### 3.2 3.0: Response to Reading Borough Council's Statement of Case

Figure 12 Assessment of Mr Taylor's Figure 3.6

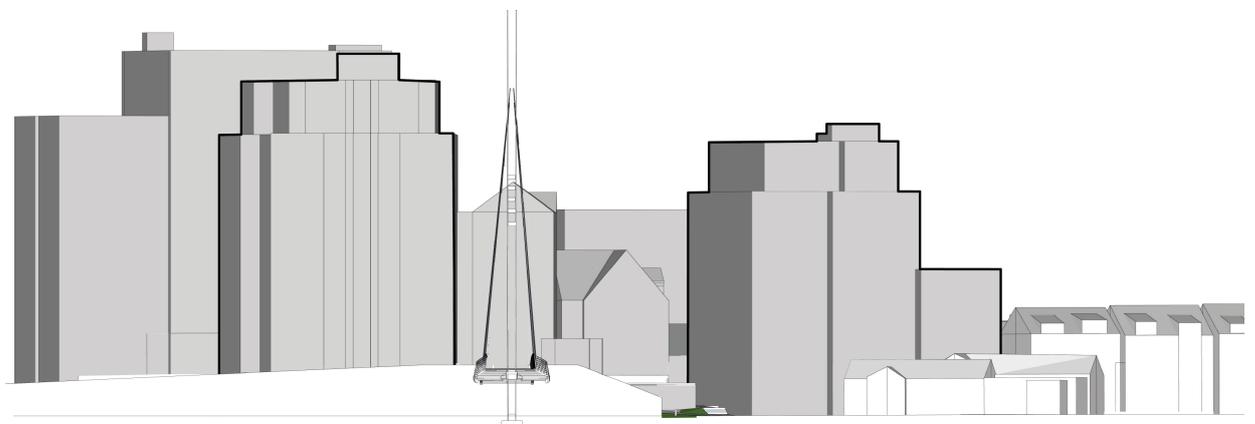
- 3.3.24 Mr Taylor's Fig 3.69 sets out to indicate that the scale of the bridge in relation to his two gatepost buildings is proportionate, and the buildings are subordinate. The Figure shows only the mast of the bridge in diagrammatic form with a thick blue line that overstates the mast's slender, white painted form. The diagram only demonstrates that the mast is taller than the riverside facades of Buildings D and E. The gap marked 'g' suggest only three prominent vertical features in the view. It does not show the actual forms and relationships or the proposed buildings behind in the gap marked 'g' that will enclose the space in an approximate horseshoe shape. I also note how much taller the appeal proposals are in relation to the adjacent riverside buildings.

Figure 13 Analysis of H, Clearwater Court (Page 92 SoC Design Appendix 14)

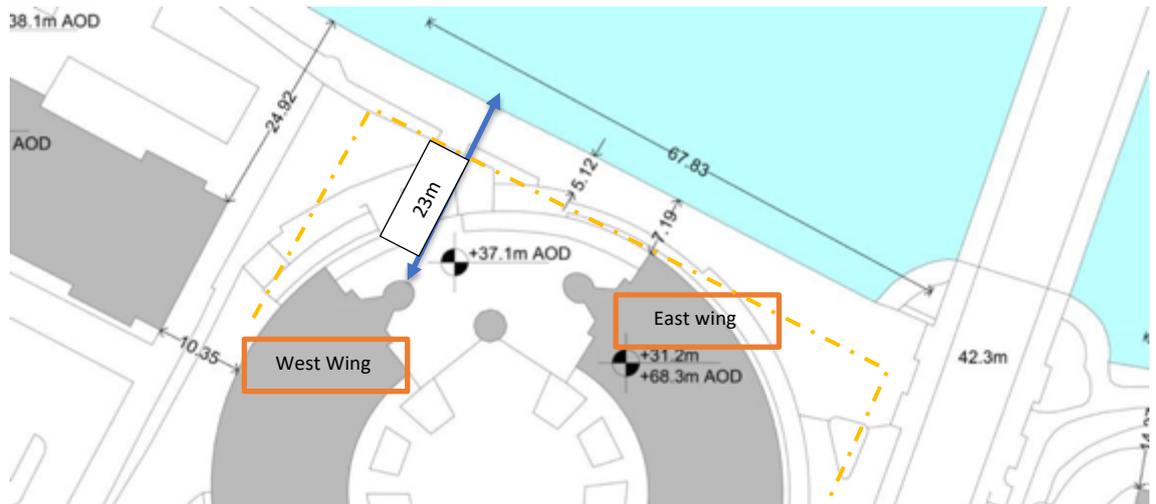
- 3.3.34 The orange dotted line shows the implication of Mr Taylor's ratio methodology, which misrepresents the distance and height relationship of the actual building to the riverside.

Figure 14 Extract from DAS page 93 - River Thames massing showing relative heights of Clearwater Court in relation to the Appeal Scheme (minus rooftop plant enclosures)

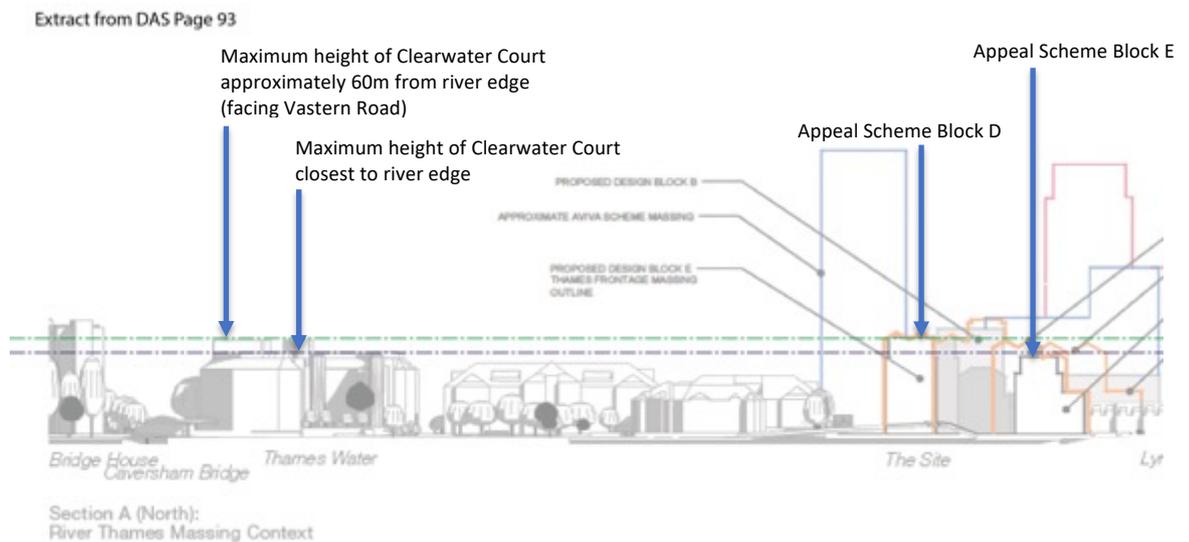
- 3.3.35 The building heights given in Mr Taylor's SoC Appendix 14 diagrams 'A' to 'I' (pages 85-93) are incorrect. Looking at DAS Figure Section A (North) 'River Massing Context' (Page 93), I see that the projecting wings of Clearwater Court (which Mr Taylor gives as 31.2m in his SoC) are considerably lower than proposed Block D (which Mr Taylor's SoC gives as 30.4m) and slightly taller than Block E (which Mr Taylor gives as 25.1m). Looking again at

the DAS Figure, I deduct Mr Taylor has taken the highest point of Clearwater Court closest to Vastern Road, some 60m from the river edge.

Figure 15 Analysis of Fig. D (Page 88) of SoC Design Appendix 14

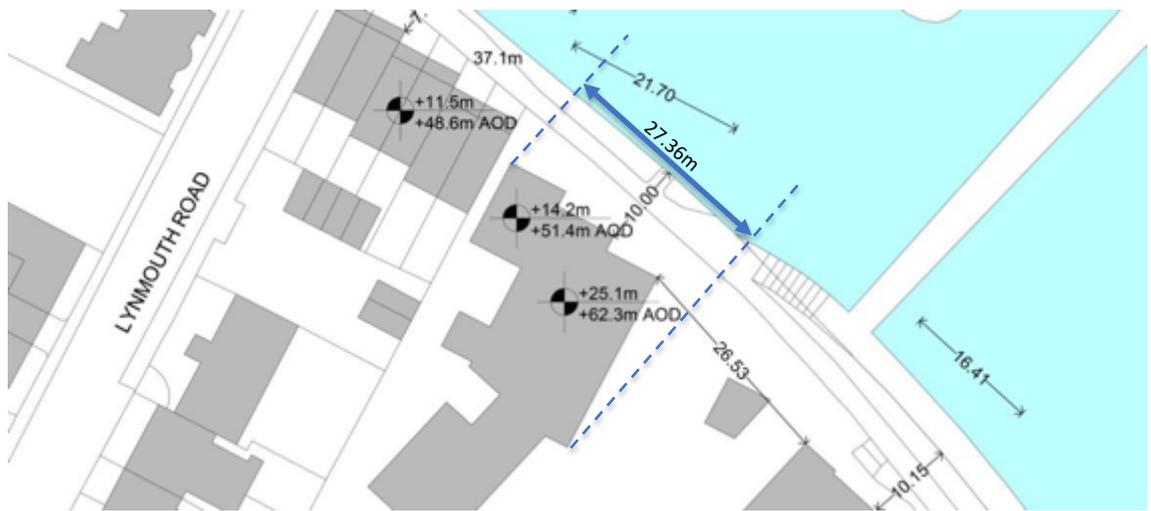
3.3.36 When representing the width of Blocks D and E, Mr Taylor adopts a different approach that is more helpful to his argument. He measures the building width in relation to the river parallel to the building frontage when it should be consistently measures parallel to the river edge and with the other riverside buildings.

Figure 16 Analysis of Fig. E (Page 89) of SoC Design Appendix 14 using the same method as for Clearwater Court

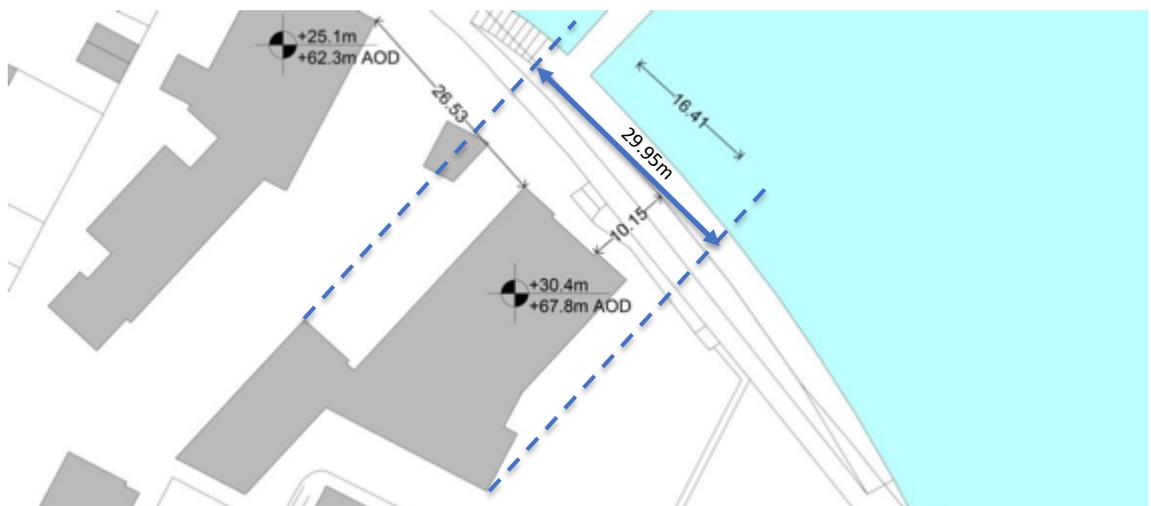
3.3.37 Mr Taylor then breaks the methodological rigour of his assessment of frontage widths to claim Christchurch Wharf and Lynmouth Court would be read together '*given there is only a slight gap between the two buildings*'. He does not apply the same logic to

Figure 17 Assessment of the relative scale, proportions, and forms of power stations

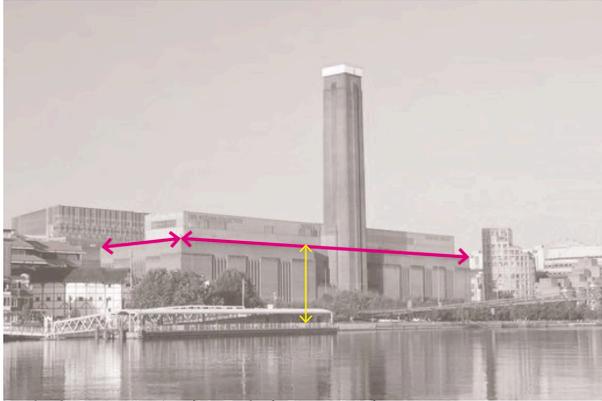
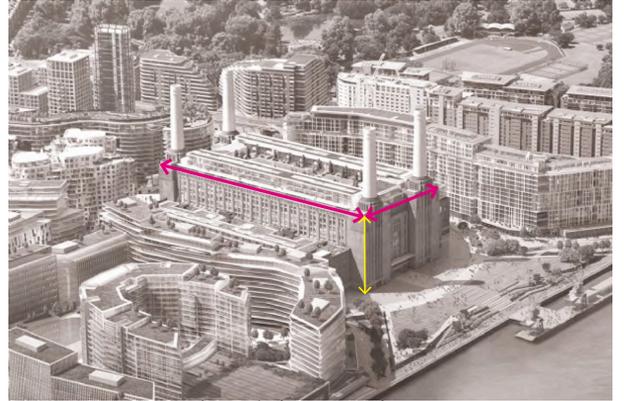
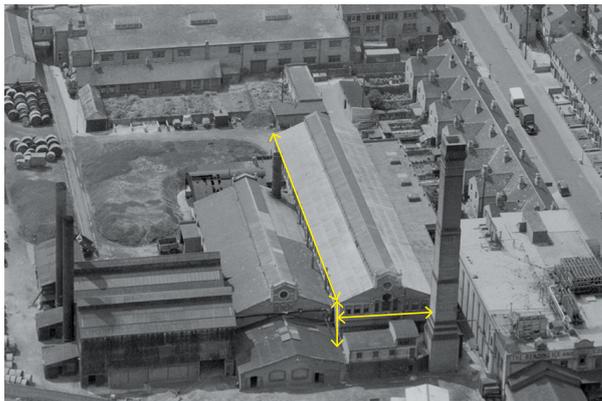
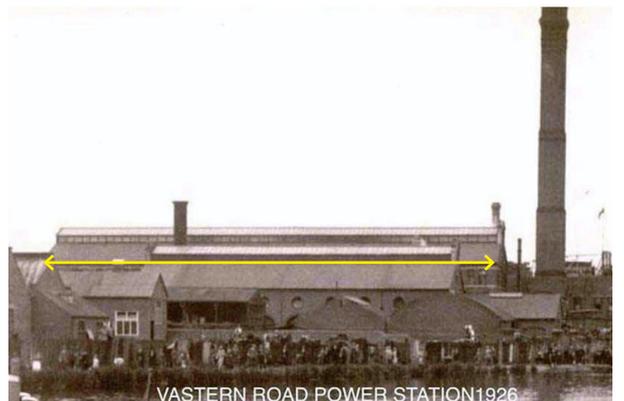
- 3.3.47 Mr Taylor provides the 'x' and 'y' dimensions of the two stations at Figs. 3.27 and 3.28. He omits the heights of the main turbine hall volumes (see Figure 17 below). In my view, the height to width ratios of the two historic stations result in lower and longer turbine halls, whereas the height of the Appeal Scheme Block D in Fig 3.29 is greater in

proportion to the longer façade. Block D does not emulate the proportions of either Battersea or Bankside, as Mr Taylor claims.

3.3.48 Finally, referring to my earlier points on 1930's power stations, the most appropriate power station typology to which Mr Taylor could have drawn was the Edwardian Vastern Road Electric Power Station (the two middle images at Figure 17 below).

3.3.49 Turning to Mr Taylor's Figure 3.30, I observe that the additional setback results in a far more satisfactory relationship between building heights, proximity to the riverside and the immediate setting of Christchurch Bridge and adjacent riverside development. Fig. 3.30 demonstrates ample scope for a better balance between height and setbacks at the riverside.

Figure 18 The Reading Power Station footprint of 1932 overlaid on the Appeal Scheme (red line) showing how this was set further back from the river (images extracted from DAS)

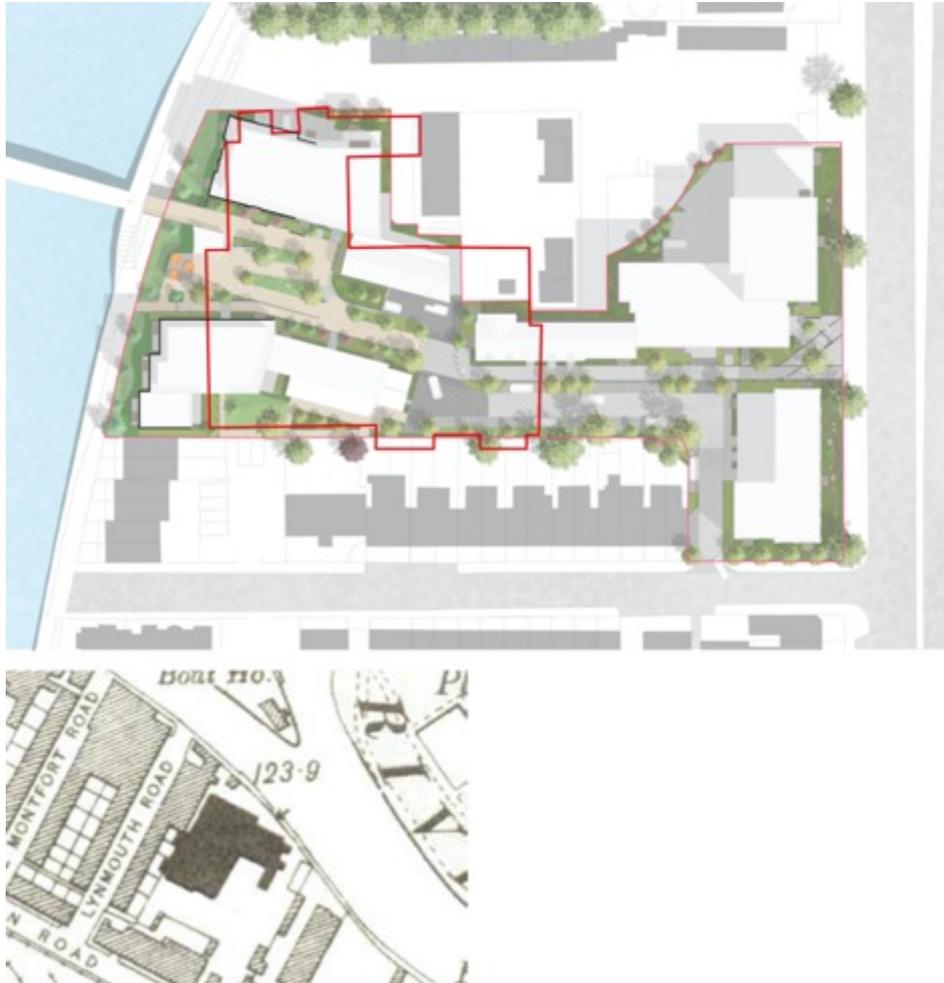
3.3.50 My Figure 18 shows the historic power station footprint of 1932 laid over the Appeal Scheme. I note that the historic station was generally set further back from the riverside.

Figure 21 Mr Taylor's Fig Ap1 and Ap 2 with alternative alignments marked

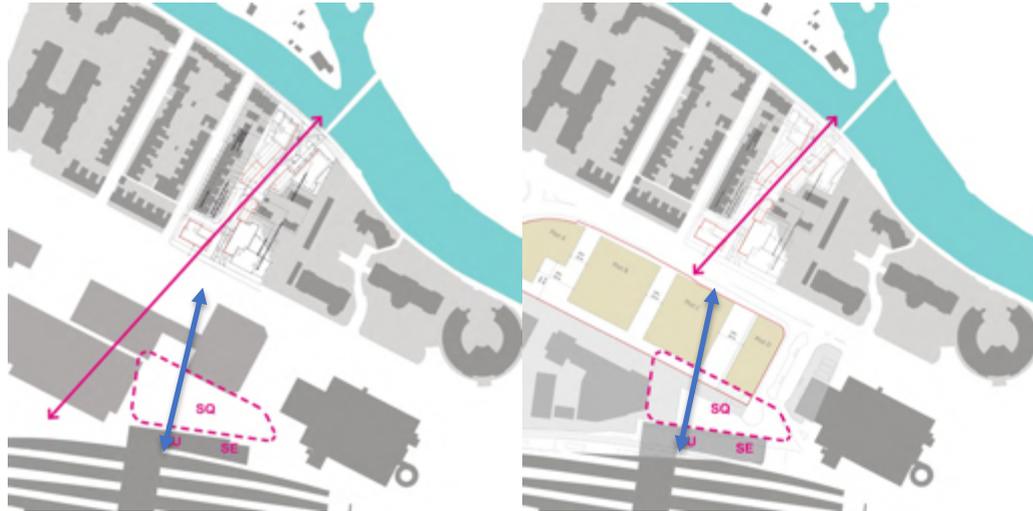
3.4.2 Mr Taylor's Figures (Ap 1 Ap2, Ap 4, Ap 5 Ap 7 Ap 8) extrude the alignments in SK-03,4 and 7 across the sites on the south side of Vastern Road before and after planned development. In my view, if it cranks at all, alignment should crank at Vastern Road - with east-west connectivity - and align with the station/station square. The Aviva/Reading Station Park planning application layout would adjust to fit.

3.4.3 My PoE (Figs. 31 and 32) examines the potential for a direct line of sight from the station to the river without any crank, which the Appellant argues is impractical.

Figure 24 The route from the southern towpath (red) and from the entrance to Block E (blue) to Christchurch Bridge is neither short nor direct.

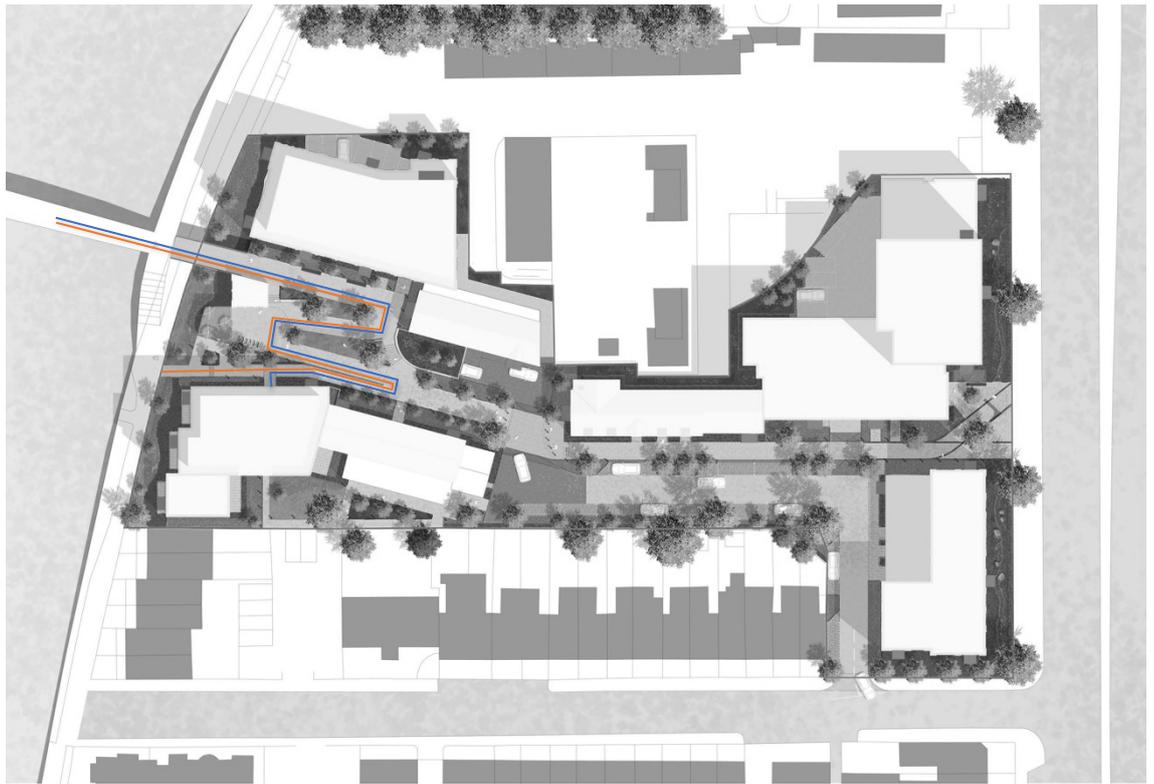
- 5.3.3 Even with an in-line ramp, the claimed disbenefits to those accessing the ramp from properties in the northern areas of the site and those using the towpath are less significant than Mr Witchalls infers. Figure 24 below shows that the route from the riverside and the entrance to Block E avoiding stairs is already long. The additional route length would therefore be less significant than Mr Witchalls suggests.

Figure 27 The footprint of the café can be adjusted (dashed black line) to open sightlines along the ramp.

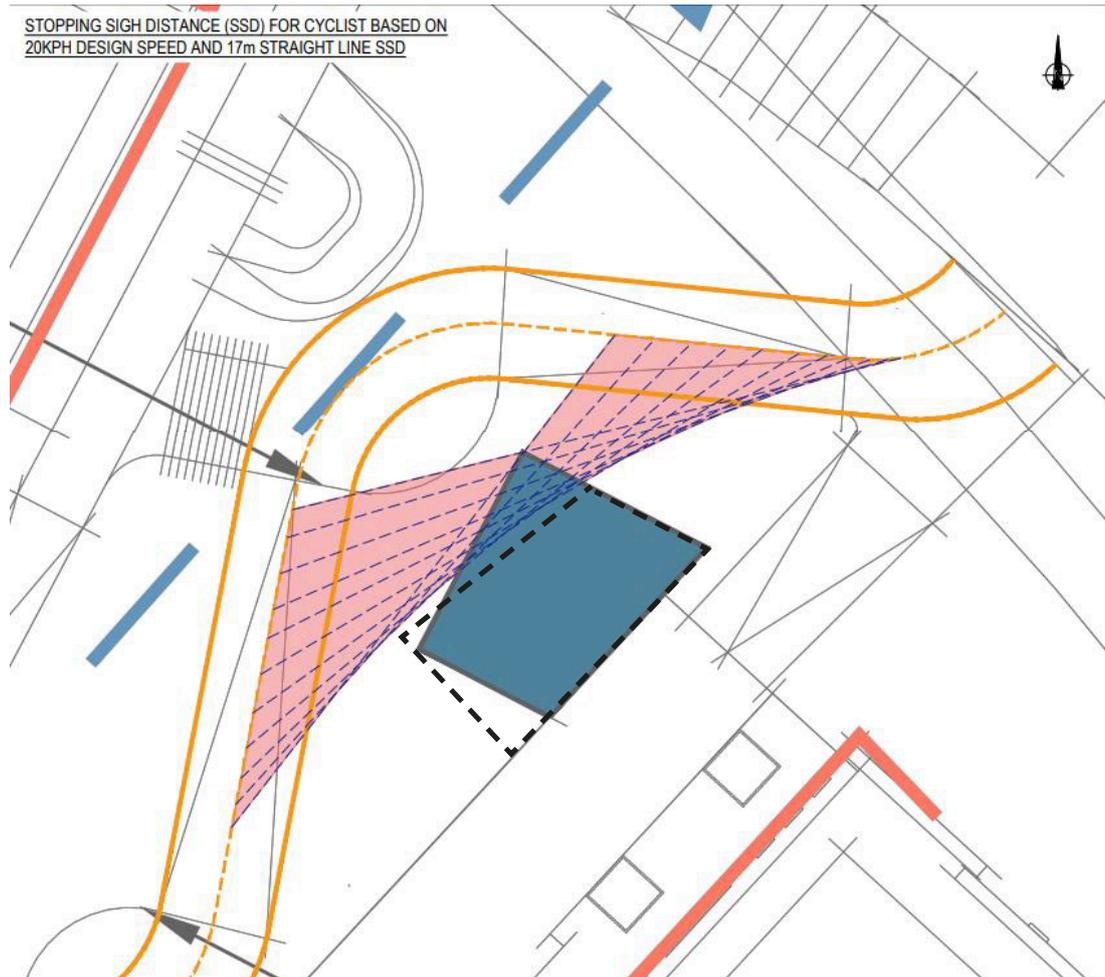
5.6.2 The forward visibility around the café is easily remedied by adjusting the Café footprint. The Appeal Proposals also lack forward visibility in the vicinity of the café.

5.6.3 The Figure below shows how the footprint of the café is easily adjusted to improve sightlines.

Figure 29 The Appeal Scheme includes a 'blind bend' where the staircase beside the café meets cyclists travelling down from the bridge into the scheme.

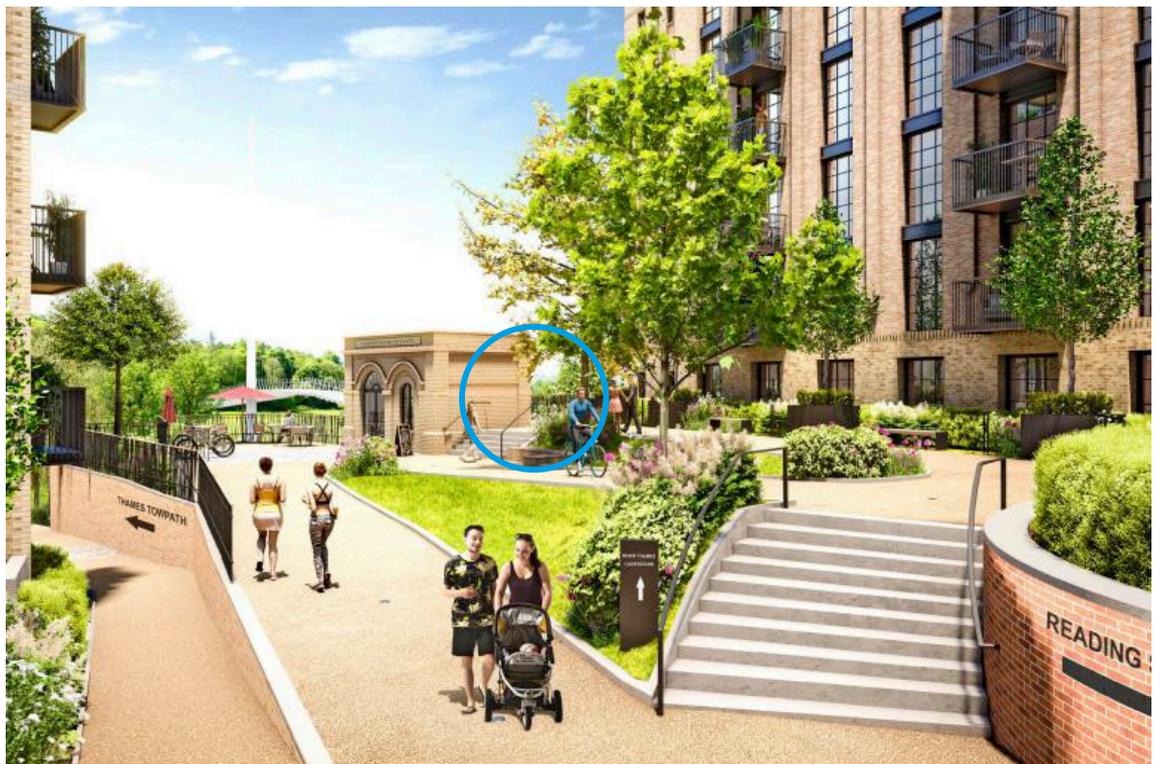
5.3.10 Mr. Witchalls' Figure 5.2c and my Figure 29 Figure 29 The Appeal Scheme includes a 'blind bend' where the staircase beside the café meets cyclists travelling down from the bridge into the scheme. below shows how the top of the ramp presents a blind spot adjacent to the café where cyclists coming off the bridge and pedestrians walking up the stairs onto the ramp will have poor forward visibility and notice of one another.
